**Approval of "PONTINI" Sensor Flush Valve
(General Acceptance No. ZC20260475F)**

Details of Fitting: 1¼" Sensor flush valve for WC

Model: PWS-MSxxx
(where "xxx" denotes the code of cover plate)

PWS-MSxxx

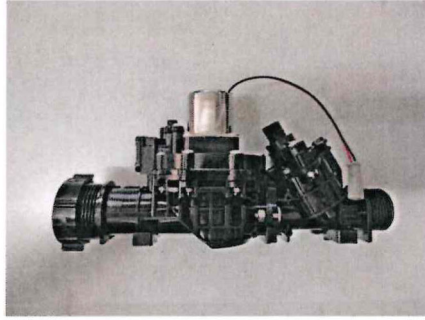
As the fitting has not been tested for use in contact with water intended for human consumption, the fitting can only be used in flushing water plumbing system.

"Installation of filter before flushing valve is required. Without the filter, the flushing valve is liable to leak. The installed filter need frequent inspection and cleaning to maintain flushing supply. Normally only public toilets with good management system for maintenance would be considered."

"A stop cock or gate valve must be installed at the upstream of the fitting for manual isolation of water supply."

"The design flushing volume of the flushing valve should be compatible with the toilet bowl to ensure that effective clearance can be achieved by a single flush of water."

"Flushing valve should be used within the range of working pressures specified by the manufacturer." AND

"Installation of electronic opening and closing sanitary tapware should also comply with the requirements of Electrical & Mechanical Services Department."
